ENGINEERING CHANGE PROPOSAL (ECP) PAGE 1

13. TITLE OF CHANGE: CHANGE DIAMETER AND TOLERANCE

a. NOMENCLATURE: YOKE, LARGE

NOTICE OF REVISION (NOR)

8. DOCUMENT NO.: 7551063

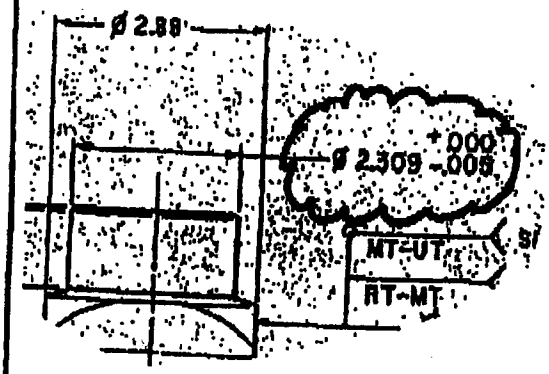
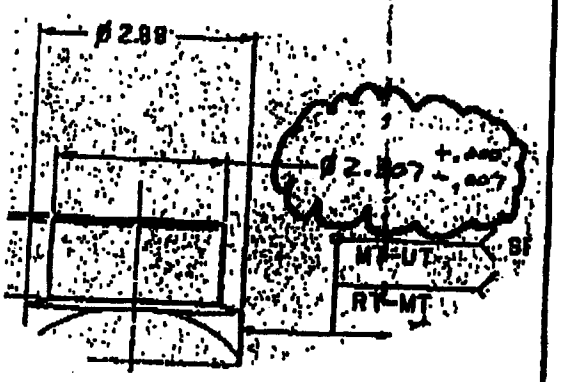
CHANGE DIAMETER AND TOLERANCE OF PLUG PORTION OF YOKE AFTER MACHINING.

CHANGE WILL PERMIT A PUSH FIT OF THE YOKE INTO THE TUBE.

THE DESCRIBED CHANGE IS WRITTEN AGAINST DRAWING 7551063, REV. H, WITH NO OUTSTANDING ACTIONS.

IN ZONES C-2 AND D-2, REVISE PICTORIALLY AS FOLLOWS:
